**Subdivision Authority**

File No. LDA08-0130

RE: Tentative plan of subdivision to create 77 single detached residential lots, 100 semi-detached residential lots, 6 medium density residential parcels and 1 municipal reserve parcel from a portion of W ½ of SE-14-51-25-4, located north of 41 Avenue SW and west of 141 Street SW; **CHAPPELLE**

**I The Subdivision by Plan is APPROVED on December 19, 2008, subject to the following conditions:**

## SUBDIVISION CONDITIONS OF APPROVAL MAP

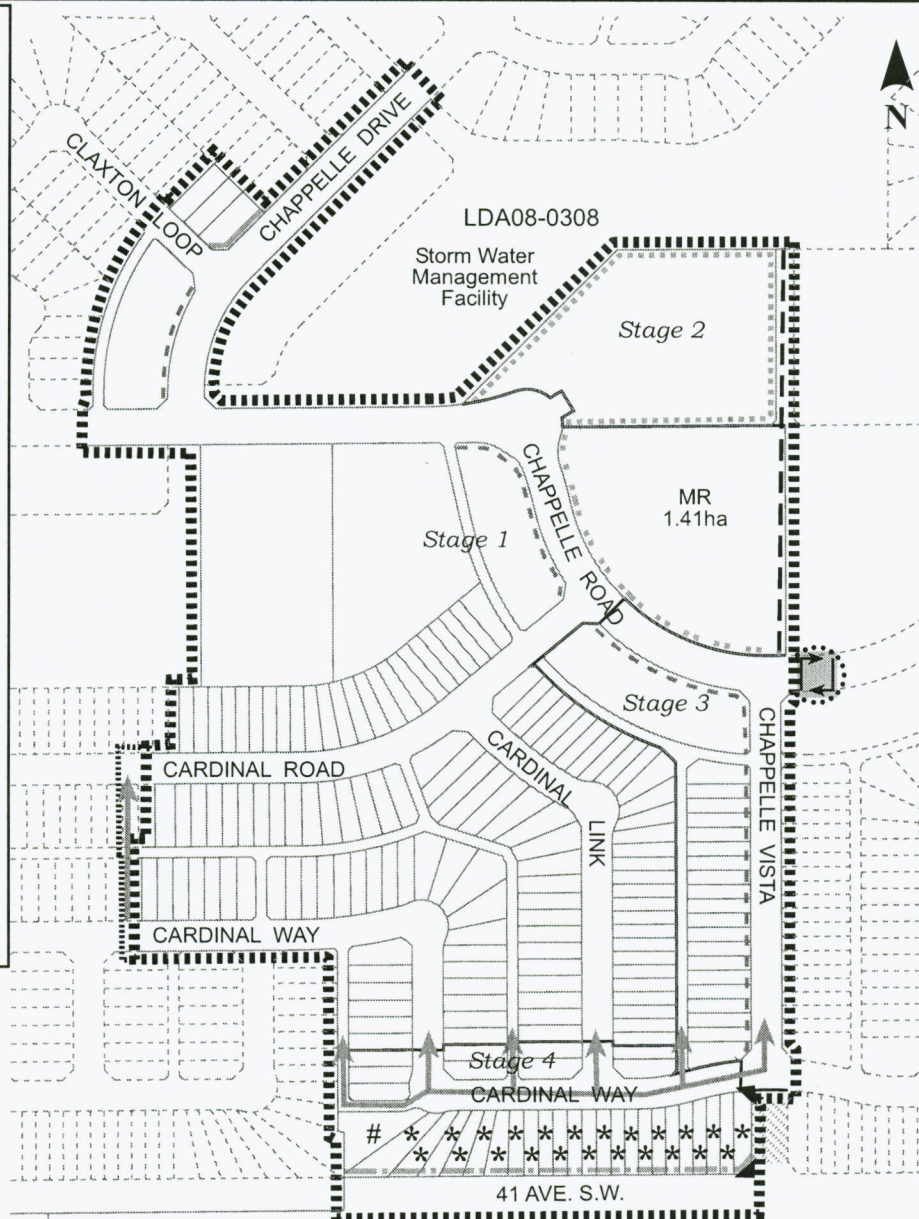
1. that the owner dedicate Municipal Reserve as a 1.41 ha parcel, pursuant to Section 664 of the Municipal Government Act, as shown on the "Conditions of Approval" map, Enclosure I;

4. that the owner be permitted to register this plan of subdivision in stages, as shown on the "Conditions of Approval" map. Enclosure I, at the discretion of the Senior Subdivision Officer, having regard to the provision of roadways and the logical extension of services;

5. that the subdivision boundary be amended to include the corner cut areas at the intersection of Cardinal Way and Chappelle Vista and at 41 Avenue SW, the areas shall be included in the land area of lot 1 in Stage 4 and the temporary roadway connection from Cardinal Road to Cardinal Way, as shown on the "Conditions of Approval" map, Enclosure I;

6. that the property line and road right of way dedication conform to an approved Concept Plan or to the satisfaction of the City of Edmonton, Transportation Department for 41 Avenue SW adjacent to the subdivision, as shown on the "Conditions of Approval" map, Enclosure I;

8. that the owner prepare a restrictive covenant in favour of the City of Edmonton that will be registered against the proposed lots backing on the noise attenuation wall as shown on the "Conditions of Approval" map, Enclosure I, to protect the integrity of the noise attenuation facility;

9. that the owner construct a 3.0 m asphalt multi-use trail with a dividing yellow centerline and "shared use" signage, as shown on the "Conditions of Approval" map, Enclosure I;

10. that the owner construct an offset 17.0 m radius asphalt temporary transit turnaround with bollards, as shown on the "Conditions of Approval" map, Enclosure I. The turnaround will be required at FAC or earlier, at the discretion and direction of the Transportation Department;

11. that the owner provide temporary roadway connections, as shown on the "Conditions of Approval" map, Enclosure I. The temporary roadway connections will be required at CCC or earlier, at the discretion and direction of the Transportation Department;

12. that the owner construct a berm and double board/no gap solid uniform screen fence to a combined height of 4.0 m within residential property lines, for all lots backing onto 41 Avenue SW, as shown on the "Conditions of Approval" map, Enclosure I;
13. that the owner construct all berms and fences positioned wholly on privately owned lands as shown on the "Conditions of Approval" map, Enclosure I; and
14. that the owner is responsible for the design, landscaping and construction within the public utility lots, utility rights-of-way, road islands, boulevards, medians, walkways, and Municipal Reserve parcels, to the satisfaction of the Transportation and Asset Management and Public Works Departments.

SUBDIVISION CONDITIONS OF APPROVAL MAP

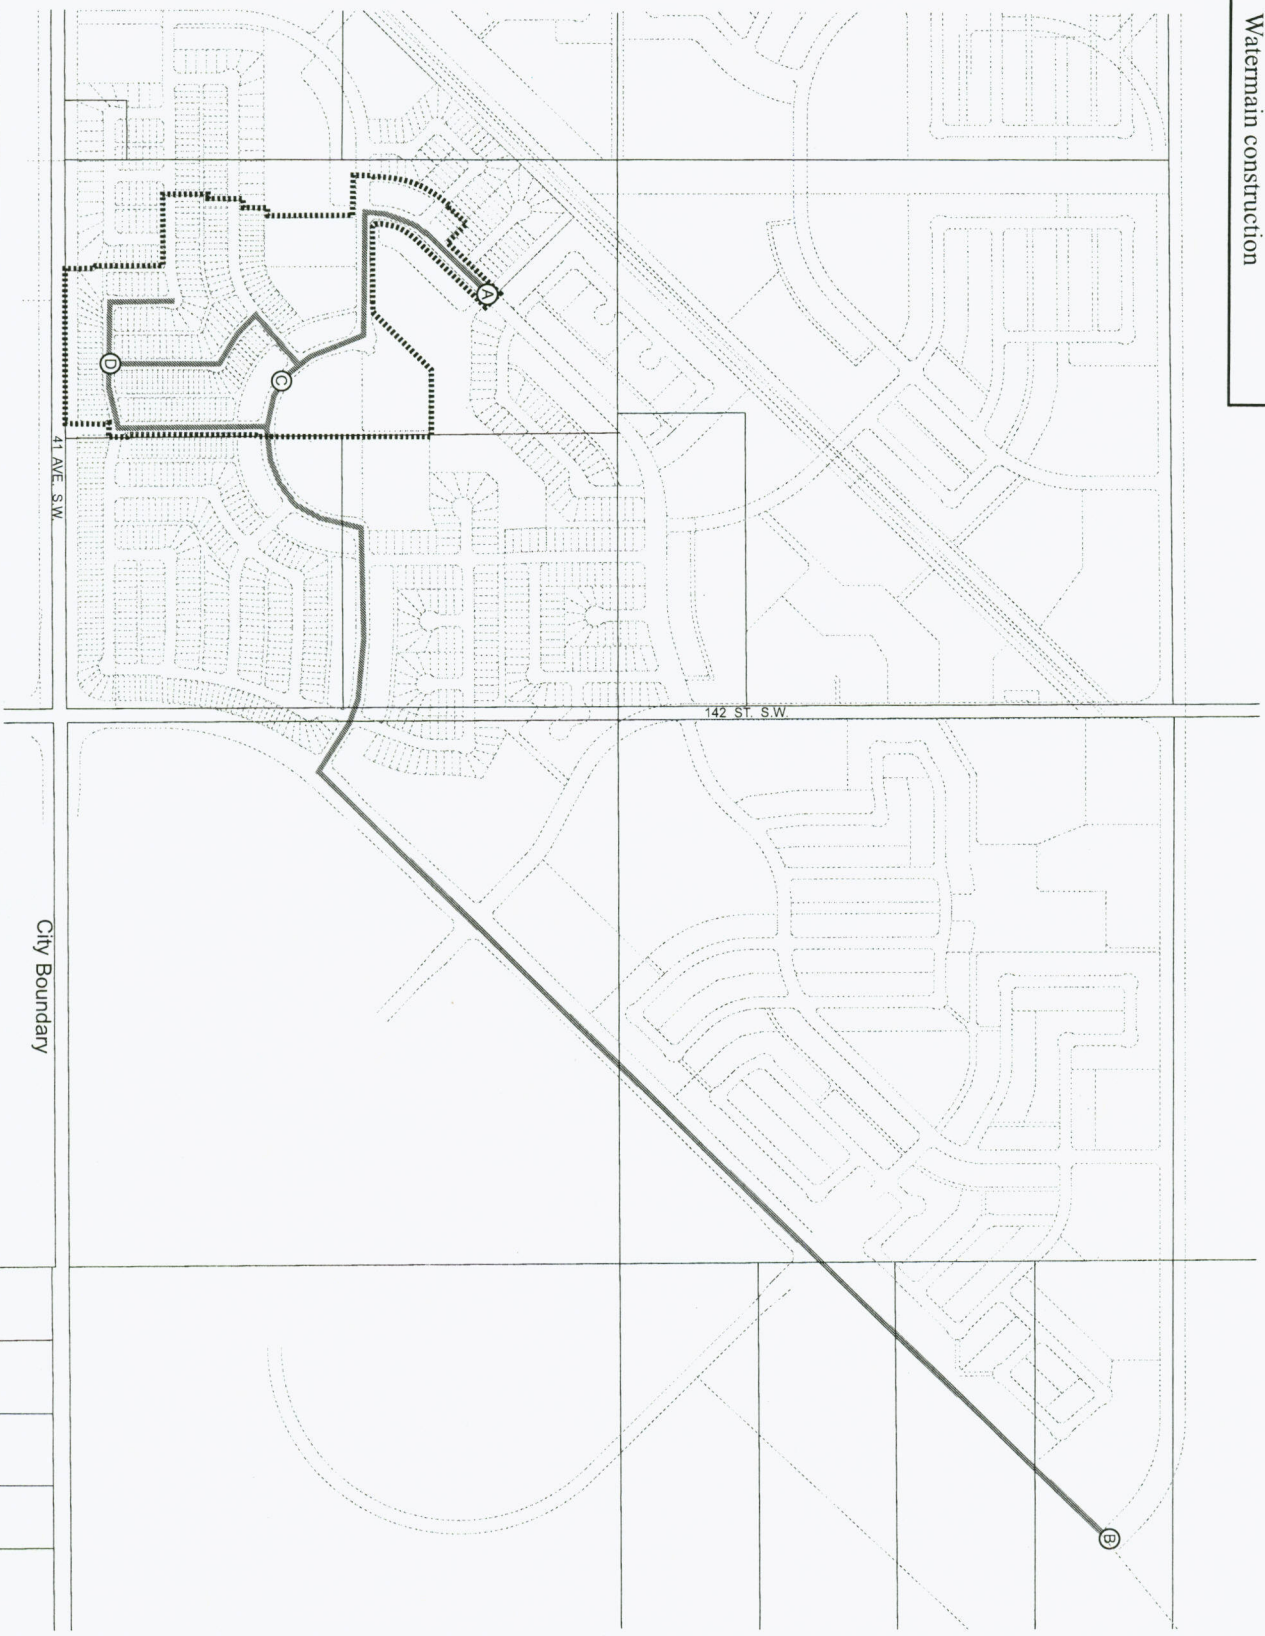
8. that the owner construct water main feeds at points C and D to provide a looped water system from points A and B, as shown on the "Conditions of Approval" map, Enclosure II;
